# Access Compliance Report

## Public Rights-of-Way

### (Pedestrian Signals)

Intersection ID: N/A	Main Street:	Cross Street: N/A	Location: N/A
ADA ID: E19B5C4F3667	Signal Type: One Push Button-Non APS	Overall Compliance: No	Severity Score: BTN 1: N/A BTN 2: N/A No BTN: N/A
Codes/Mitigation Info/Possible Solution		Field Measurements/Component Compliance

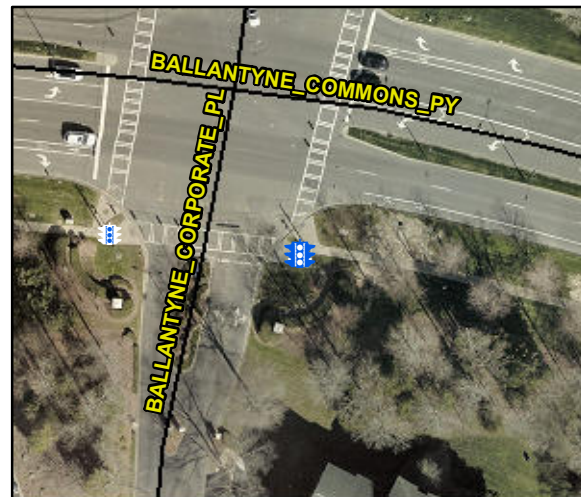
Surveyor Notes: N/A

PROW/ADA: TMUTCD 4e.08, R404.2, R406.2

Possible Solutions: Replace Signal Push Button With APS Button on New Post. Remove & Relocate Sign.
